ADDENDUM NO. 1

**Administration Building Renovation Re-bid
Compton Community College District**

tBP Project. No. 20987.00

tBP/ARCHITECTURE

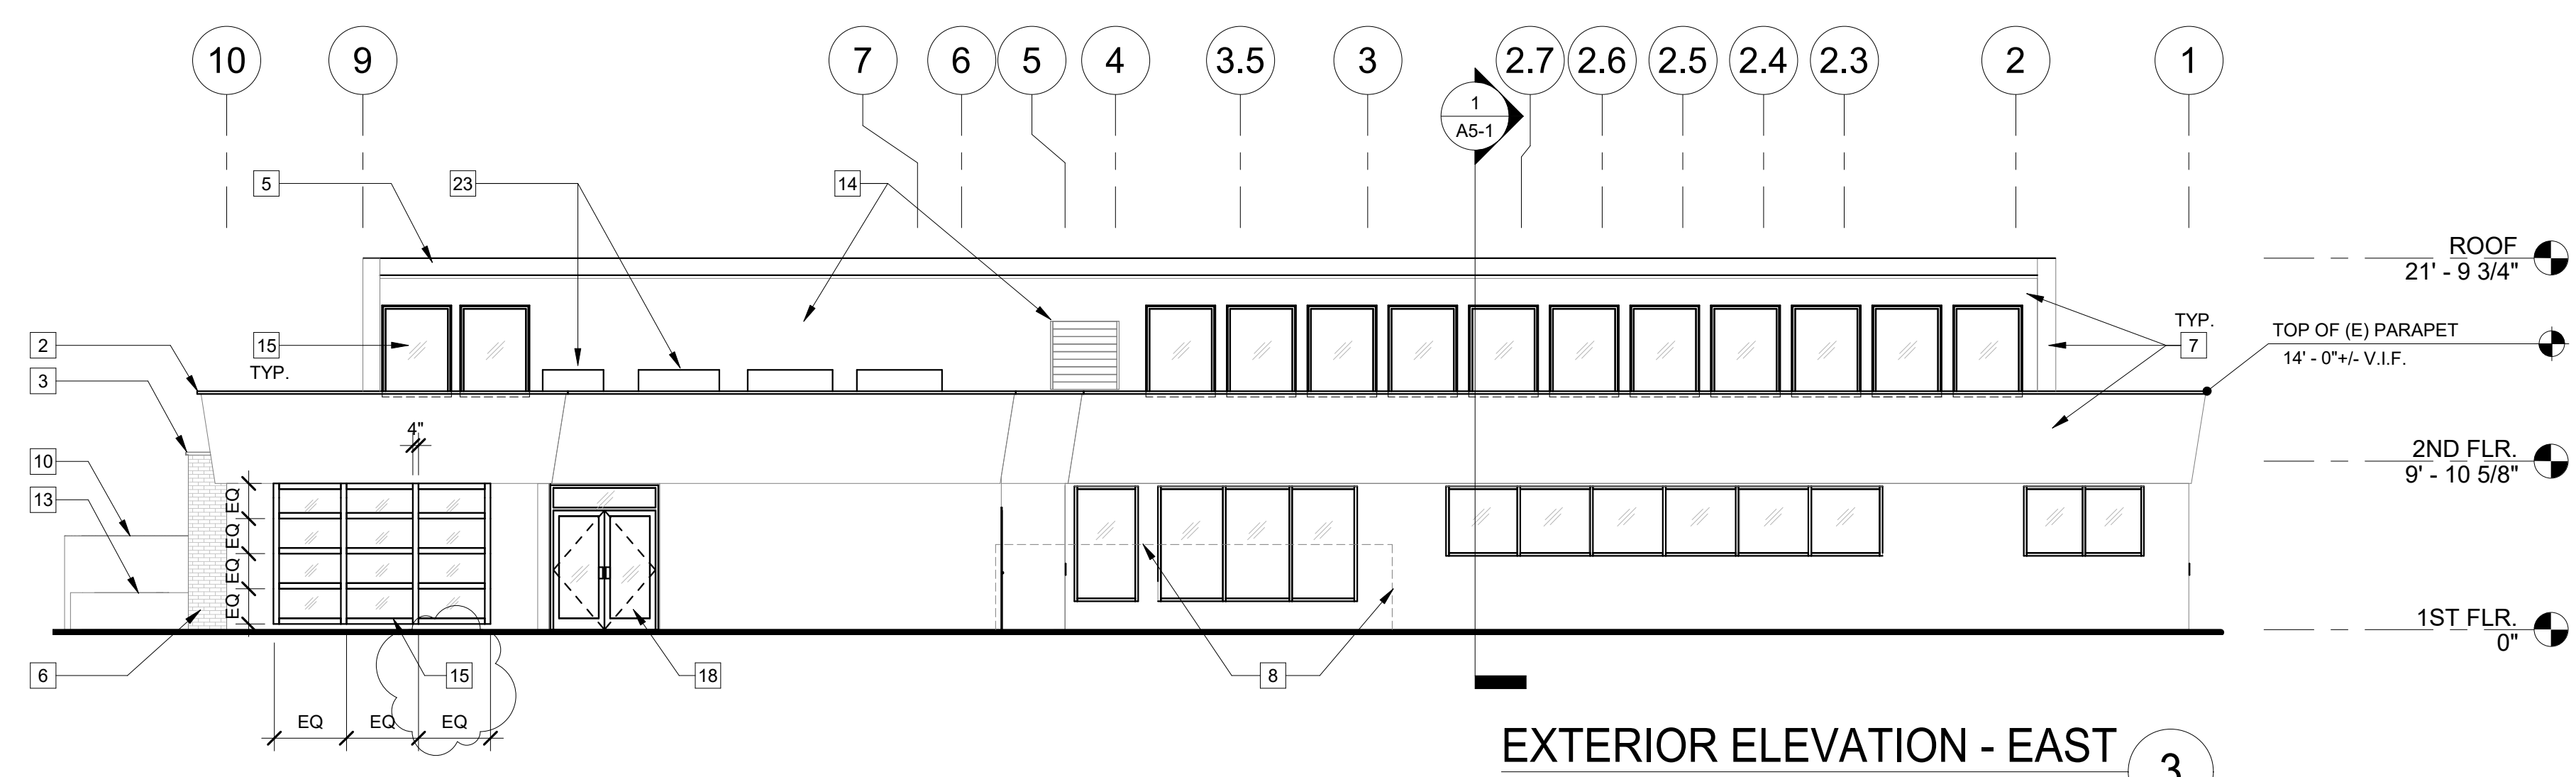
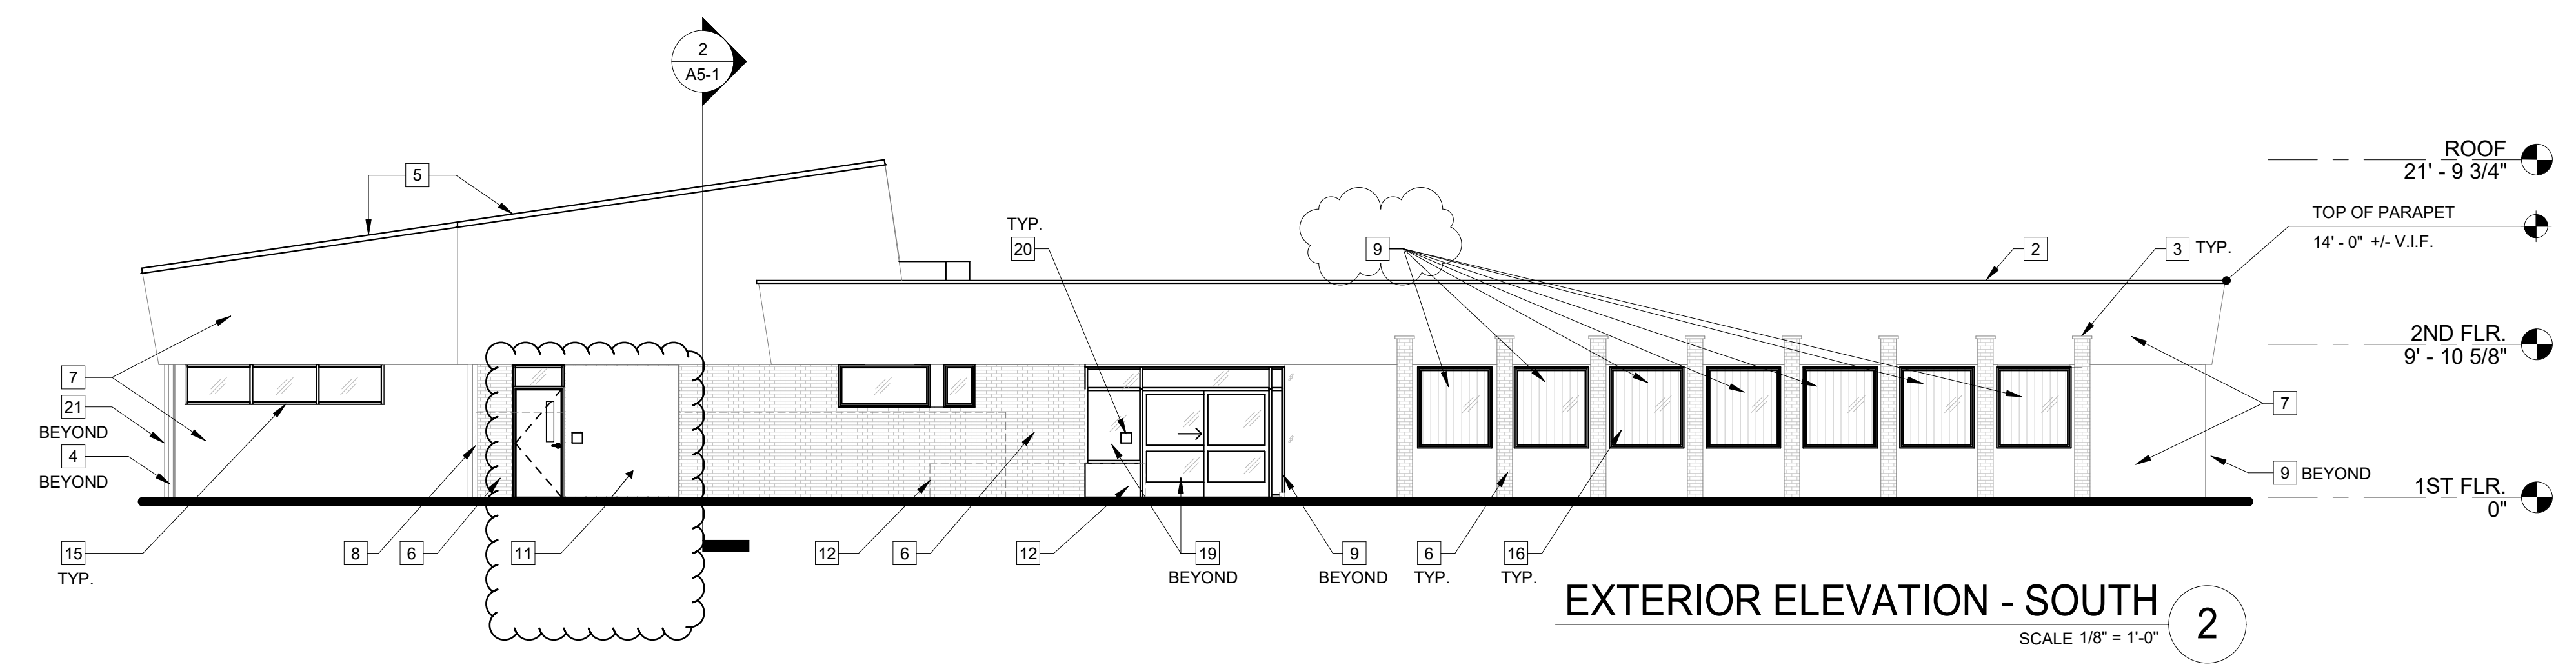
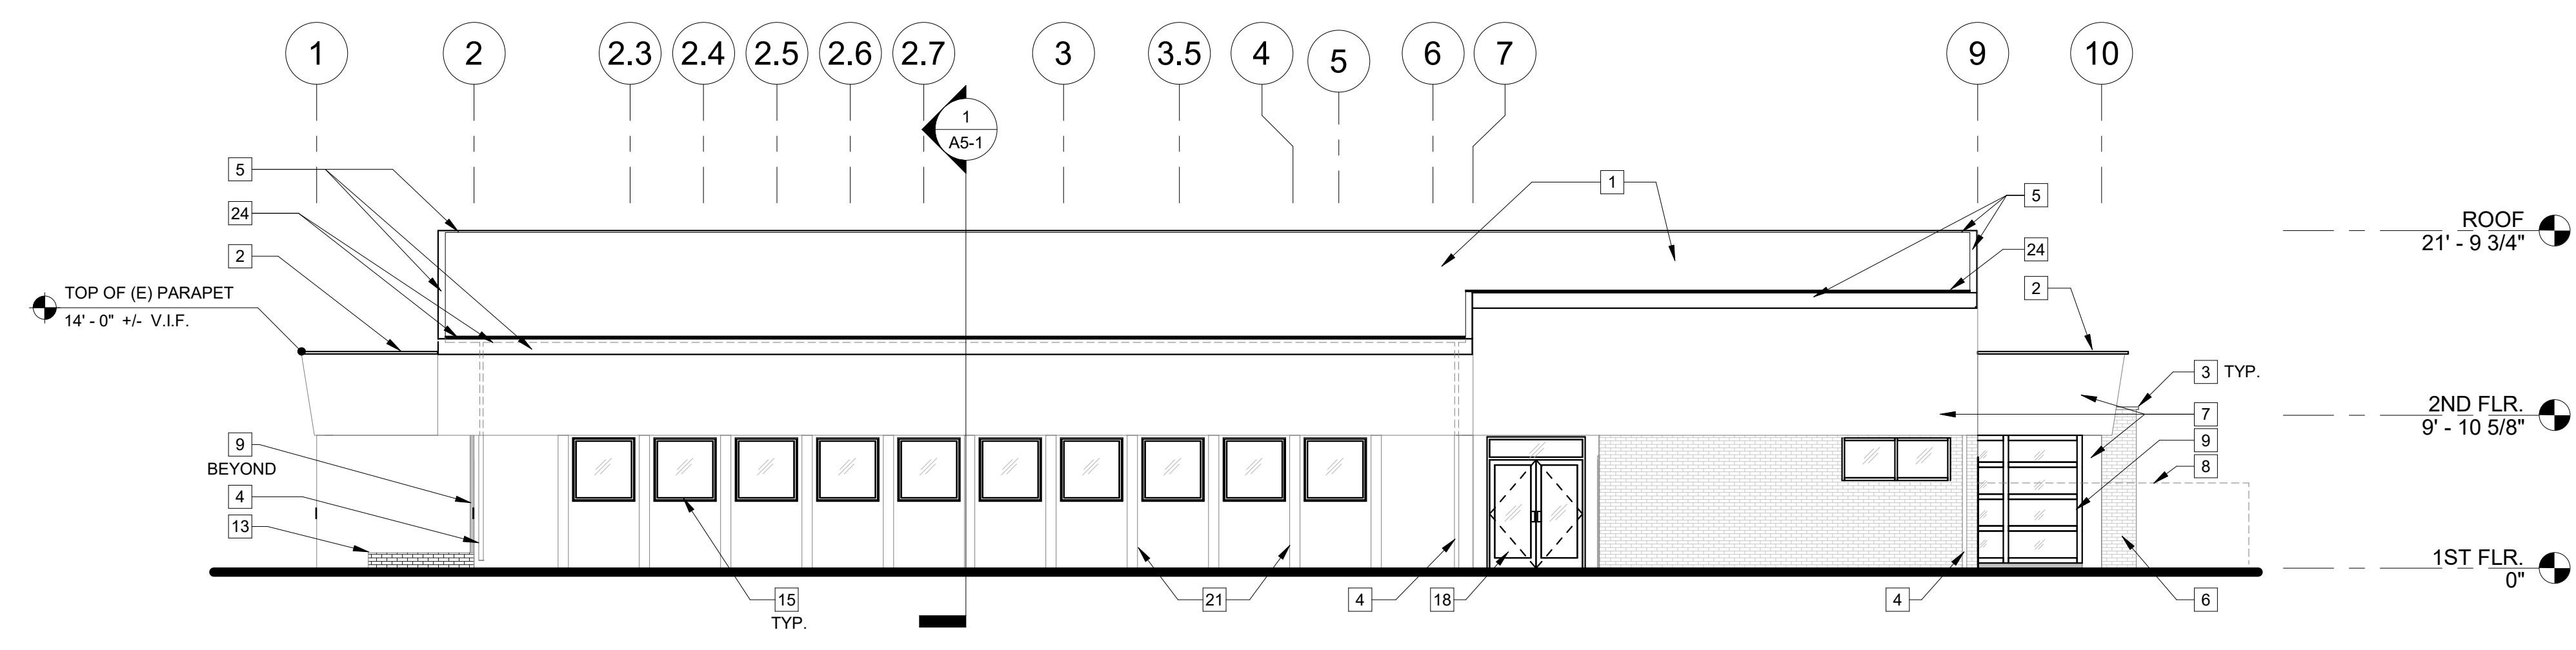
8. Revised SHEET A4-1 EXTERIOR ELEVATIONS

- a. South exterior elevation scope has been revised to omit some new windows at south elevation.
- b. Added new window to east elevation.
- c. Removed brick veneer from scope of work.
- d. Keynote 15 and 22 revisions.
